STAFF RECOMMENDATION
1805 Lakehurst Avenue
May 19, 2021

Application: New Construction—Addition; Setback determination
District: Lockeland Springs-East End Neighborhood Conservation Zoning Overlay
Council District: 06
Base Zoning: R6
Map and Parcel Number: 08310025100
Applicant: Matthew Schutz
Project Lead: Melissa Baldock, melissa.baldock@nashville.gov

Figure 7. The survey for the property show that much of the rear of the house sites on the rear property line and part of the existing addition is in the unimproved alley right of way.

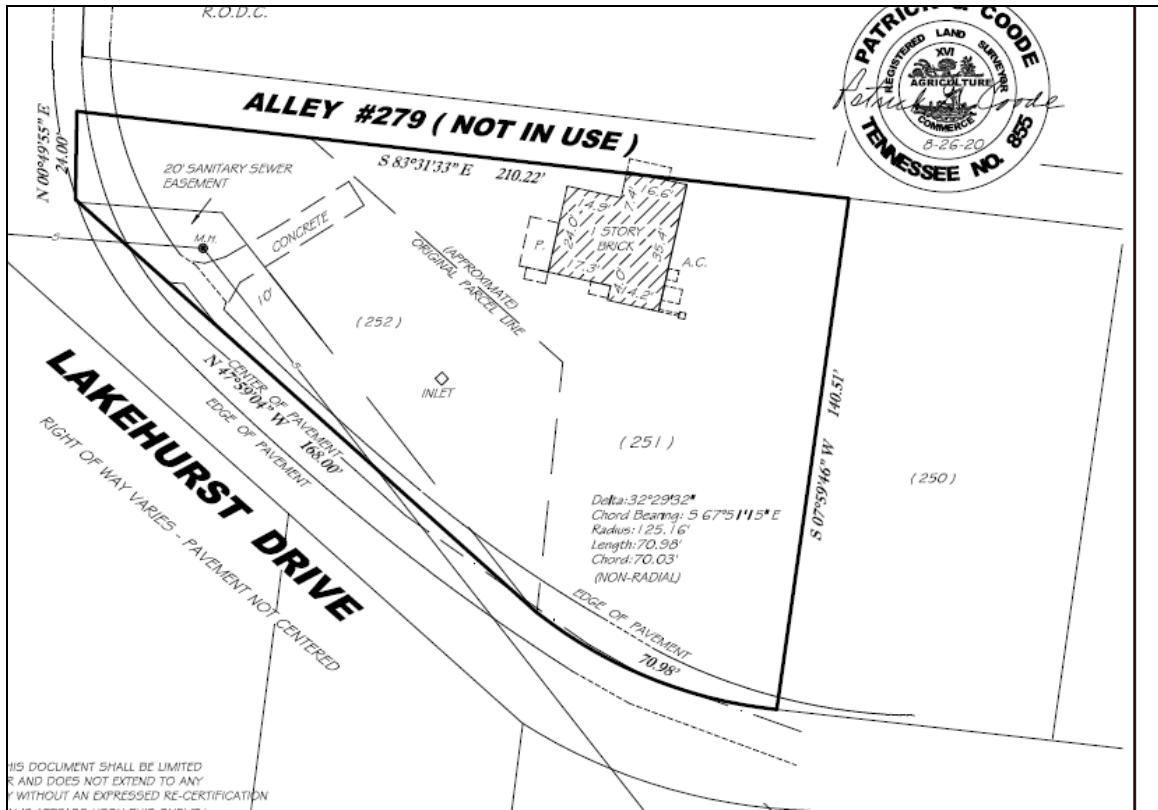
The house was built at the back of the lot, with a deep front yard setback (Figure 7). Part of the addition at the rear is currently located over the property line and into the unimproved alley right-of-way.

Figure 10. c. 1968 PA photo, which shows the house pre ridge raise.

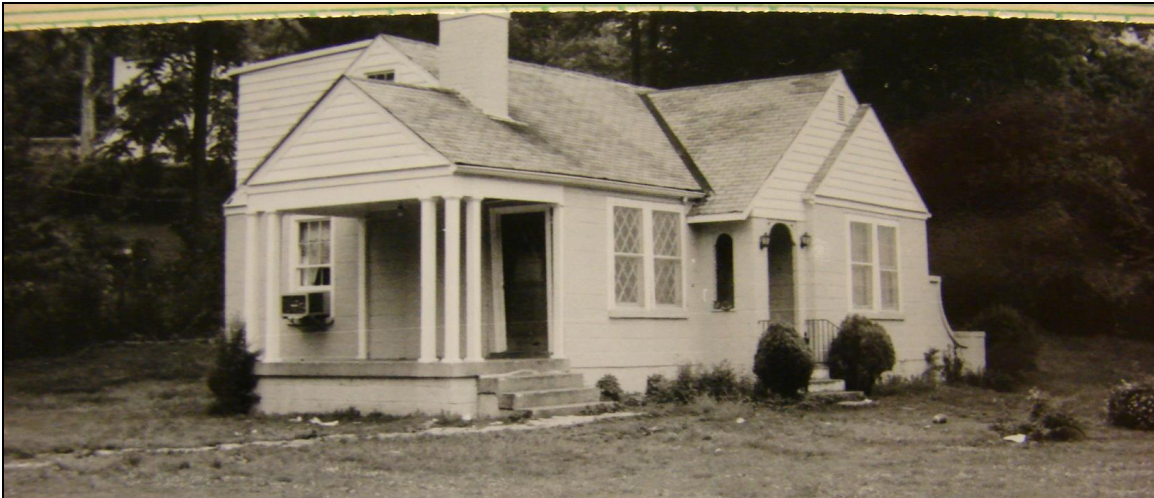
The applicant also proposes to remove an existing ridge raise (Figure 9). The date of this ridge raise is not known but it does not appear in the c. 1968 PA photo (Figure 10), so its date of construction and overall design does not contribute to the historic character of the house. The ridge raise isn’t on the 1968 photo but the rear dormer is. It will be replaced with a ridge raise that meets the design guidelines for ridge raises. Staff therefore finds that the

removal of the existing ridge raise meets the design guidelines for partial demolition.

SITE DIAGRAM NEW [1/8"=1']

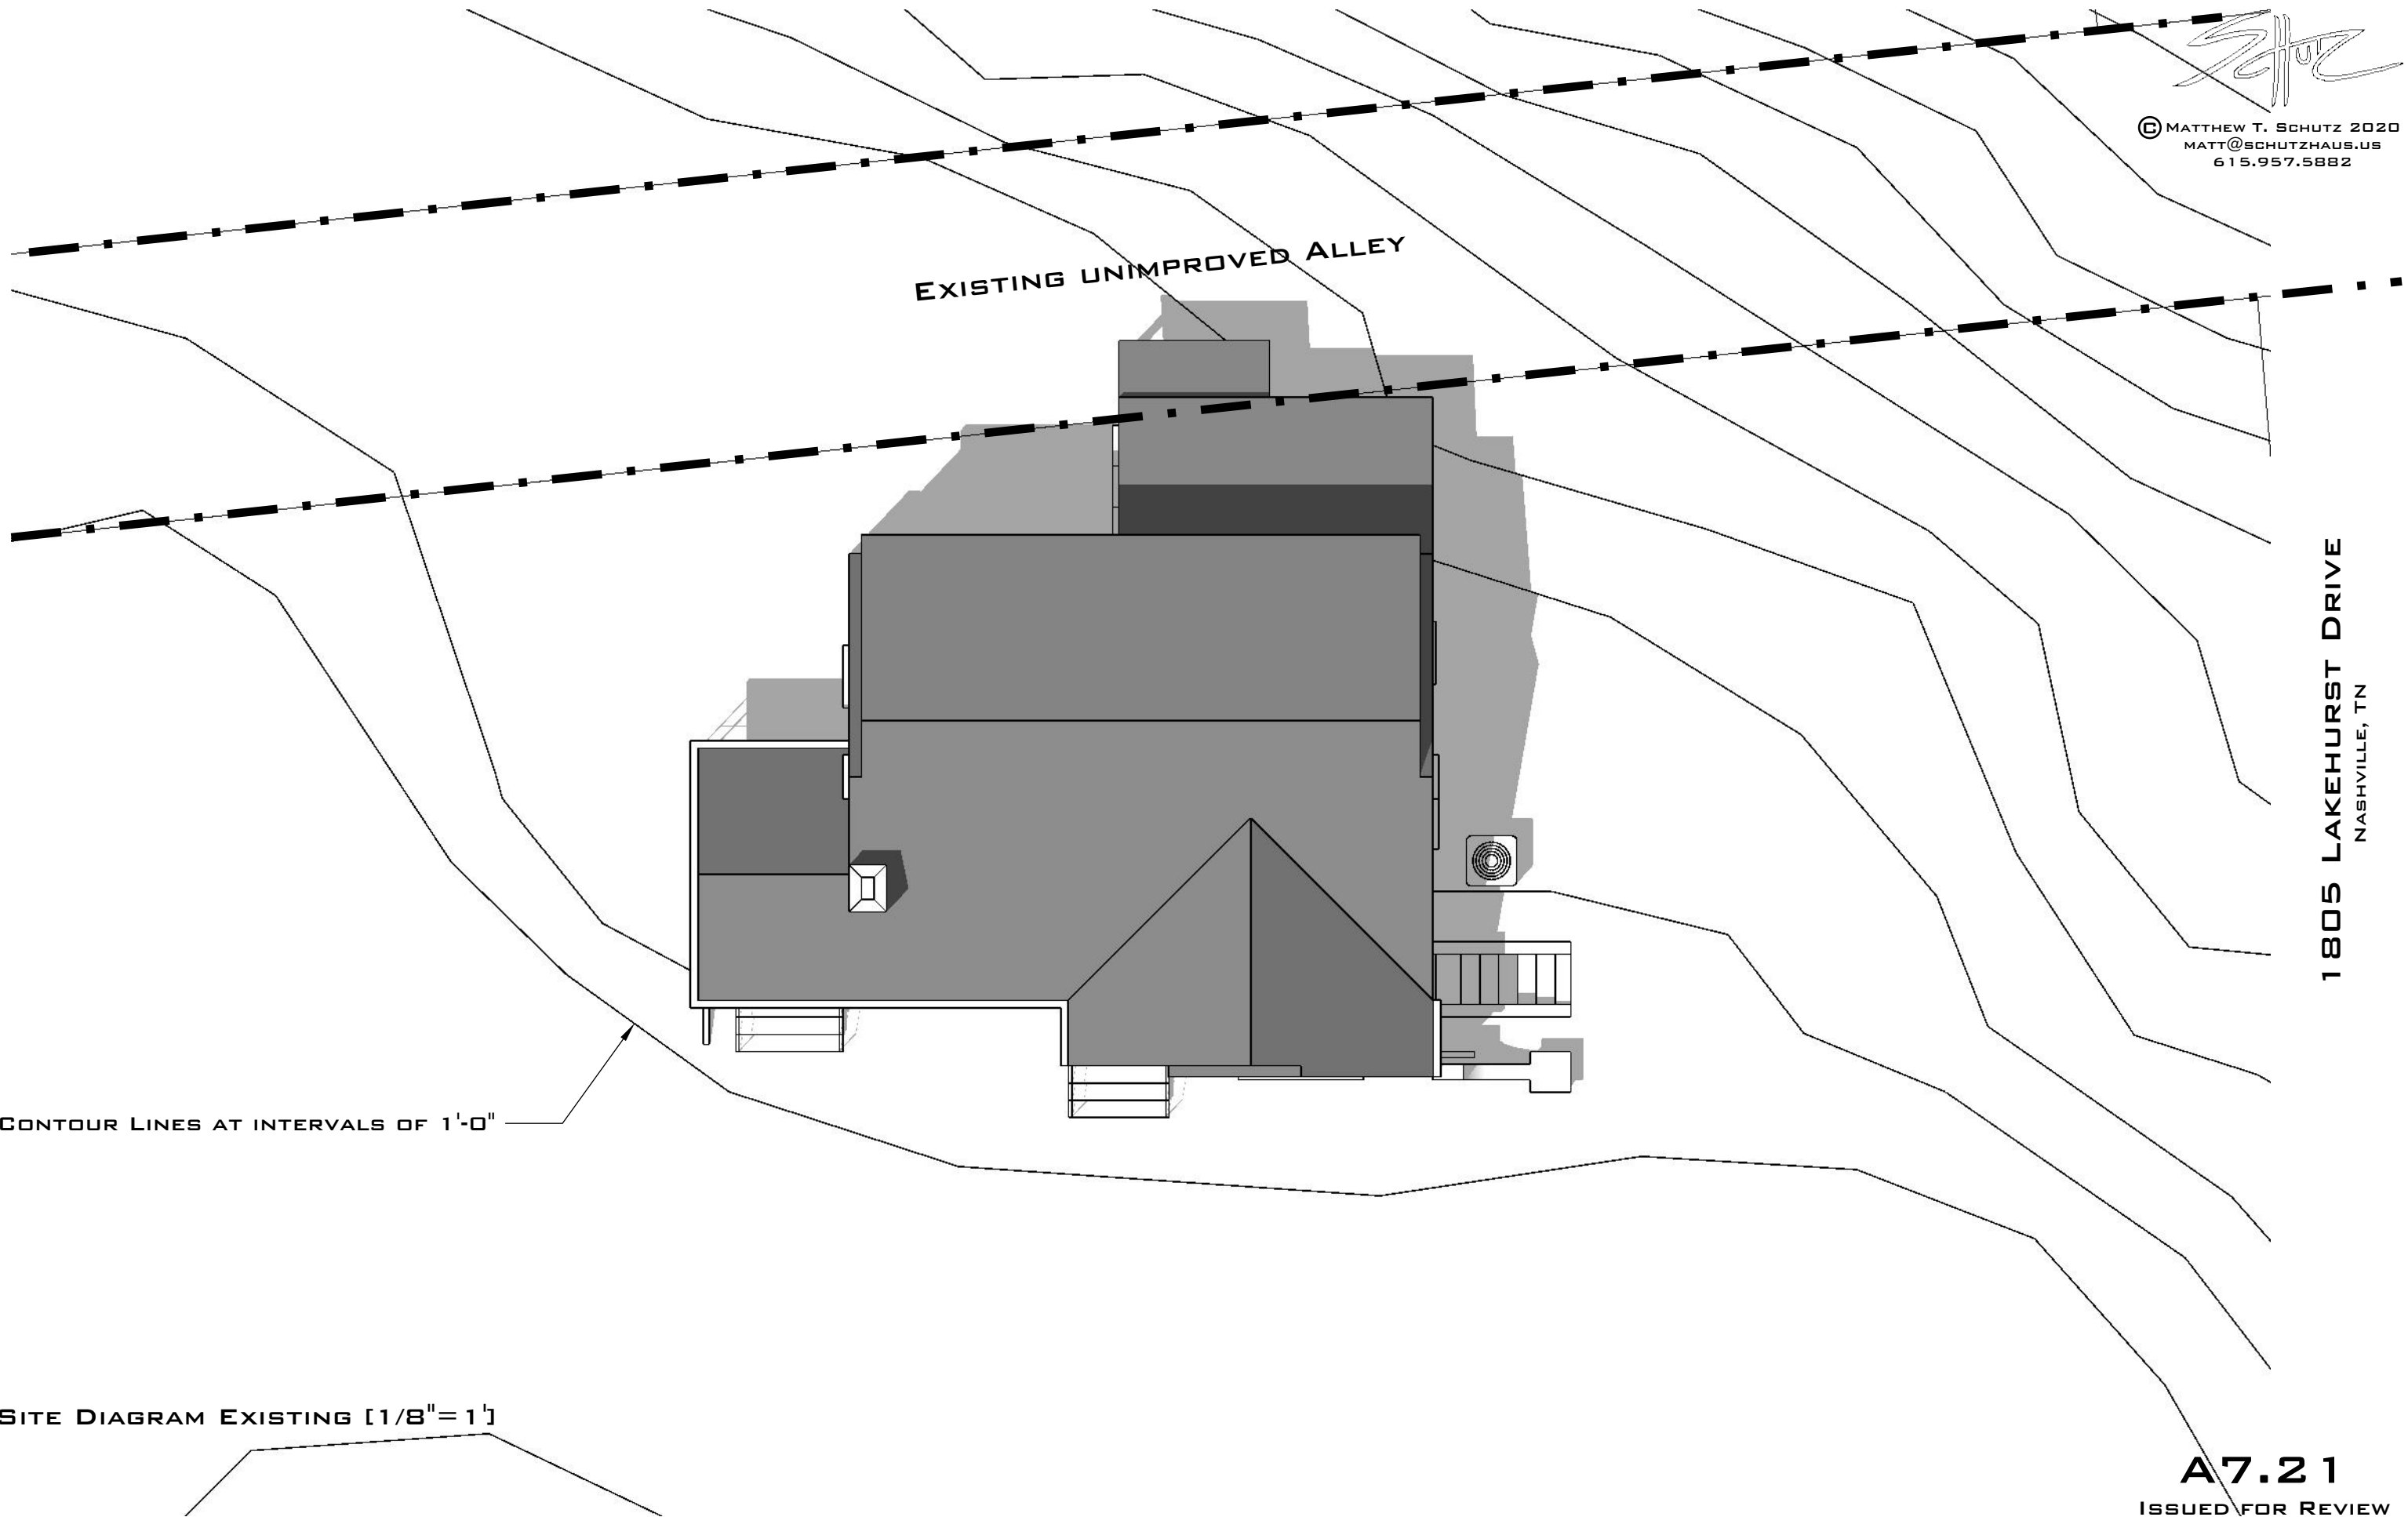
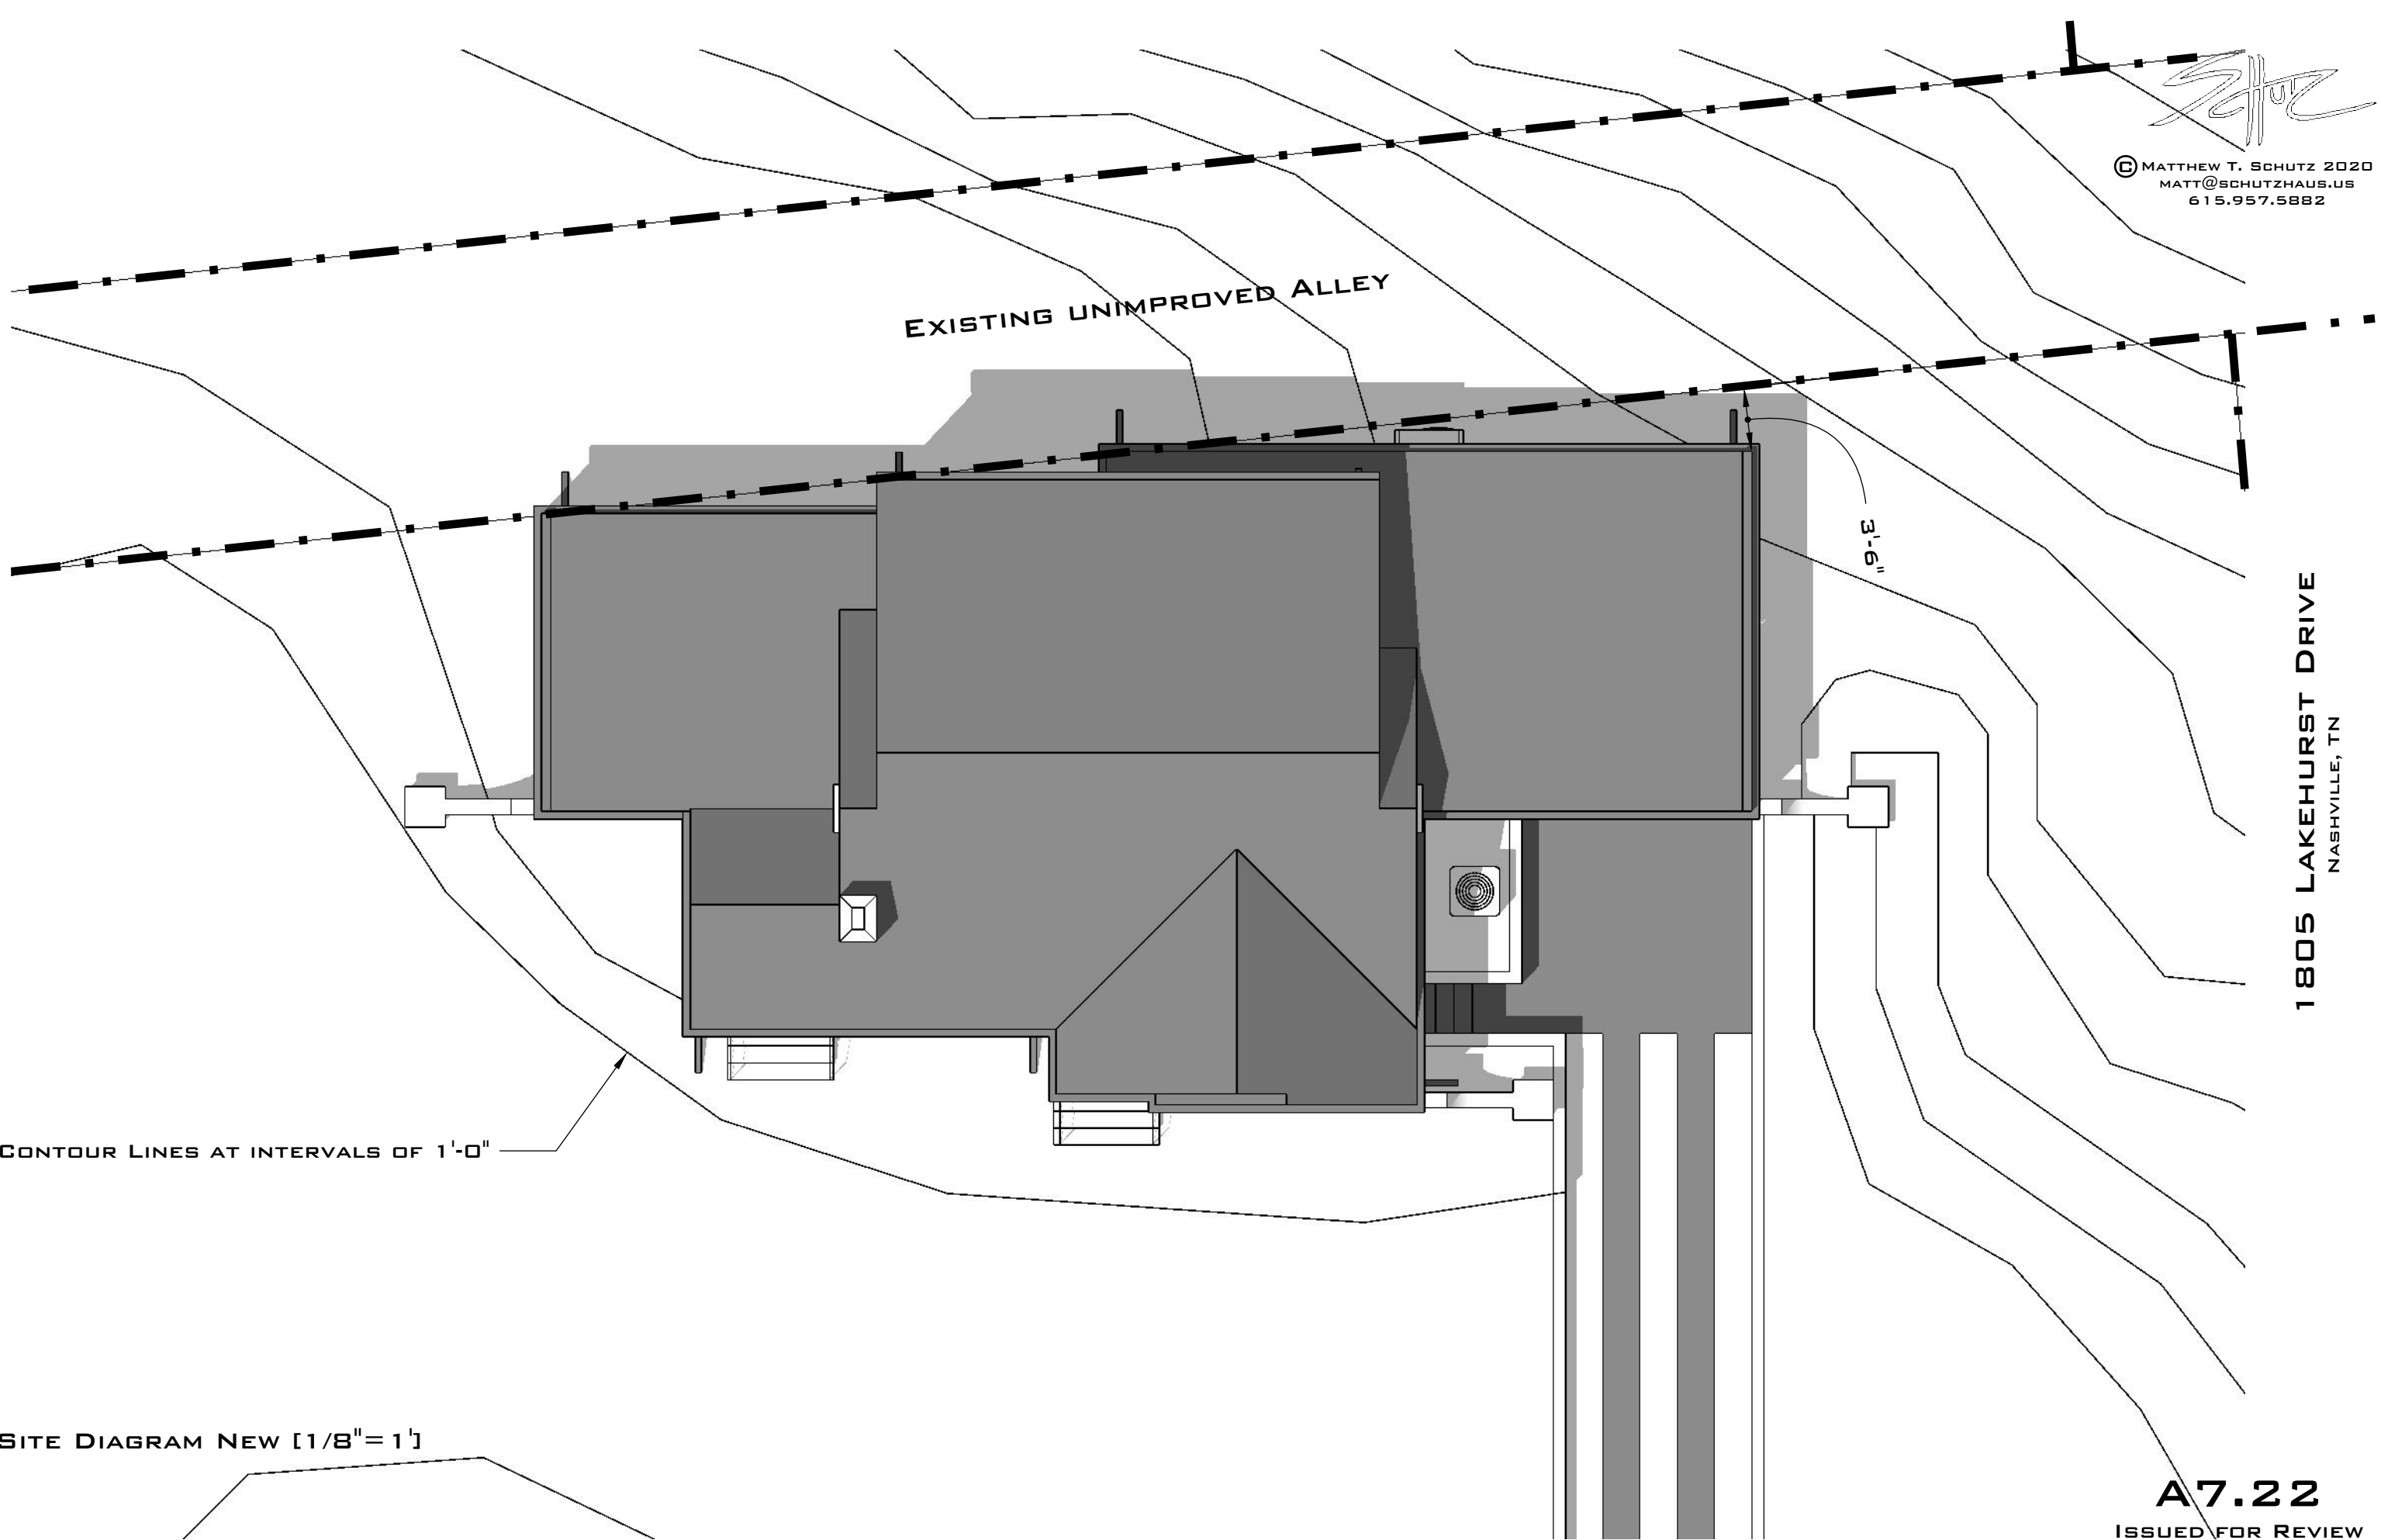
Setback & Rhythm of Spacing: The addition meets the side setbacks. It will be approximately twenty-five feet (25') from the right side property line and over one hundred feet (100') from the left side property line. The addition will not meet the twenty-foot base (20') zoning setback. The historic house, not including the existing addition that is to be removed, is less than seven feet (7') from the rear property line. The rear and side additions will extend back to the rear property line. Beyond the rear property line is an unimproved alley right of way. Because of this, there is not the concern about how the addition will affect the ability for drivers to see down the alley. Also, the unimproved alley provides a buffer between the back of this house and the properties that front Ordway behind it. There is other construction in this right-of-way behind other houses, such as fencing and possibly outbuildings. Because of that, the chance that the alley will be improved is minimal.

Because of the house’s location at the back of the lot, and because of the unimproved alley, staff finds the proposed rear setback of zero (0’) and the side setbacks to meet Section II.B.3. and II.B.10. of the design guidelines.
